Subject: Submission re: 42 Surf Road, Nth Curl Curl (DA2018/1932)

DEVELOPMENT APPLICATION DA DA2018/1932 PROPOSED NEW DWELLING WITH SWIMMING POOL AT 42 SURF ROAD, NORTH CURL CURL

Image 1: Private Outdoor Living area – adjacent to the boundary with 42 Surf Road

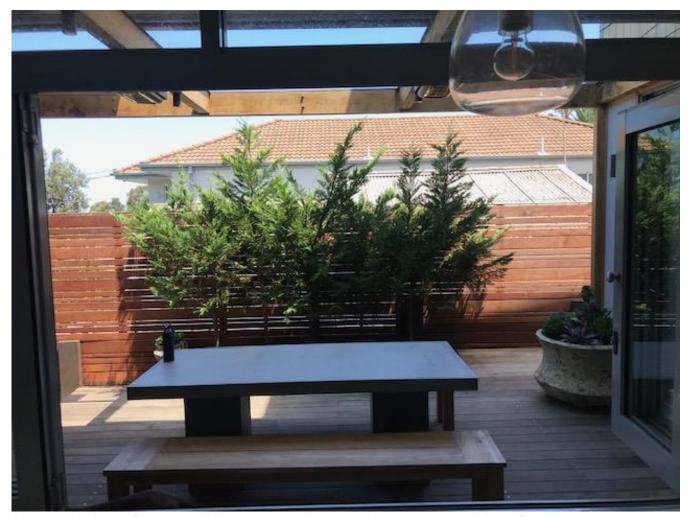
The images show that the privacy of my Clients will be significantly impacted. The potential to overlook into these primary living areas is of great concern. It is also unclear as to why parts of the upper level balcony face 40 Surf Road where it won't capture any views and only increases the risk to privacy. It is also the third storey of the dwelling which it is considered to be unreasonable in the context of the streetscape and of single dwelling development in general in the area. The SoEE refers to the proposal as a two storey development in relation to its justifications regarding privacy which, again, reflects the attempt to mislead to consider the development as only 2 storeys.
